Catalyst Bicester Transport Assessment

Wendlebury Road, Bicester

Road Safety Audit Stage 1

23 May 2019

B. Key Plan – Wendlebury Road, Bicester

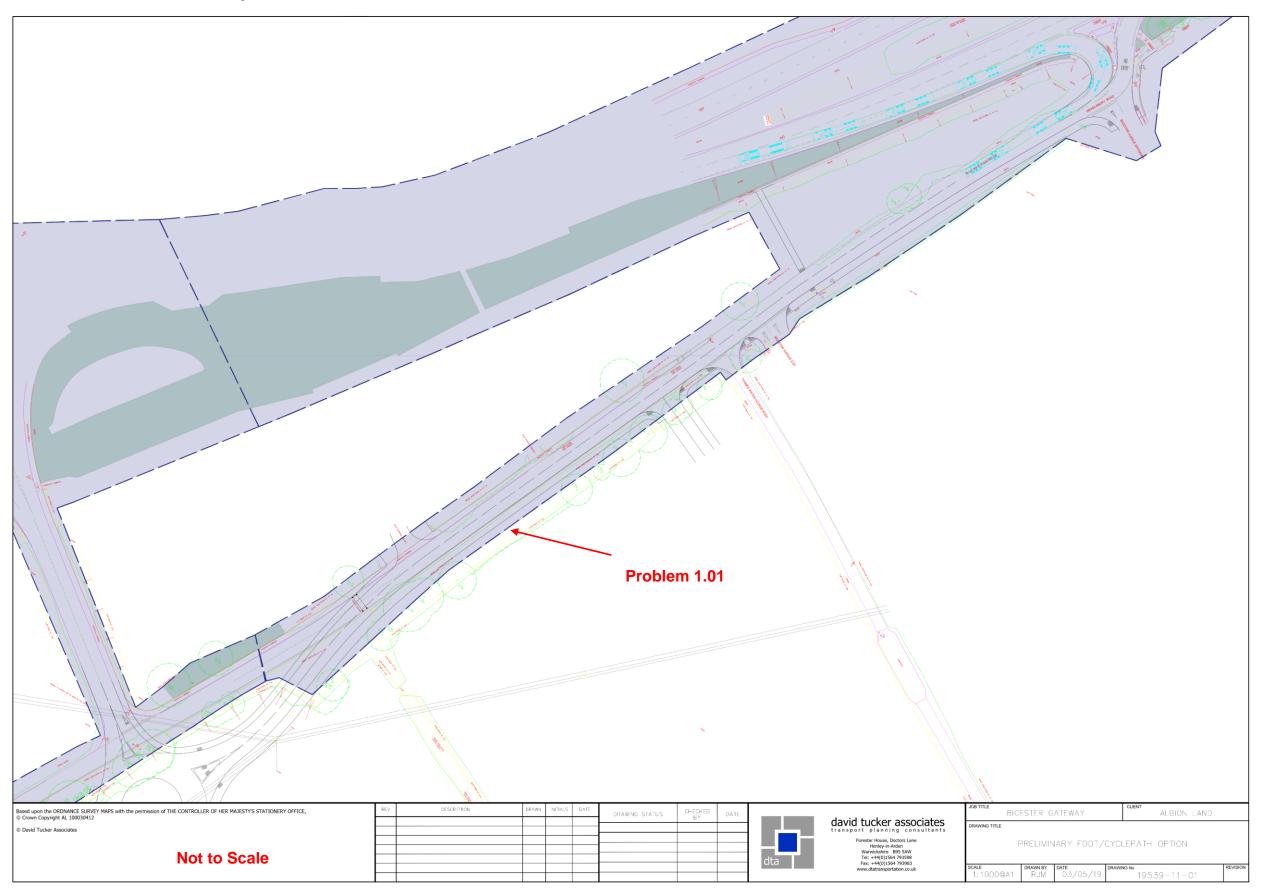
2.1 **Problem 1.01**

Location: Southern side of Wendlebury Road.

Summary: Drop at back of footway may present a hazard to pedestrians.

A new 2.5m footway / cycleway is proposed along the southern side of Wendlebury Road. There is an overgrown ditch running the length of Wendlebury Road throughout the scheme, with a noticeable level difference from the carriageway level to the bottom of the ditch. Provision of a footway at this location will result in drop at the back of the footway, which may present a hazard to pedestrians or cyclists should they leave the paved surface. This may result in falls resulting in personal injury.

2.2 **Problem 1.02**

Location: Wendlebury Road - western extent of scheme.

Summary: Unclear end of footway / cycleway.

A new 2.5m footway / cycleway is proposed along the southern side of Wendlebury Road. It is proposed that this will continue to the west of the proposed roundabout, but there are no existing footway / cycleway provisions on this side of the junction. It is unclear if there will be a demand in this direction and therefore the continuation of the footway / cycleway may encourage users continuing to the west to enter the carriageway increasing their vulnerability to being struck.

It is recommended that a fence or guardrail is provided at the back of the footway wherever a drop to surrounding surface levels is present. Alternatively, ground at the back of the footway should be graded to avoid a steep drop.

It is recommended that appropriate tie-ins with surrounding facilities are provided. If no pedestrian / cyclist demand is anticipated in this direction, the footway / cycleway to the west of the roundabout should be omitted from the scheme.
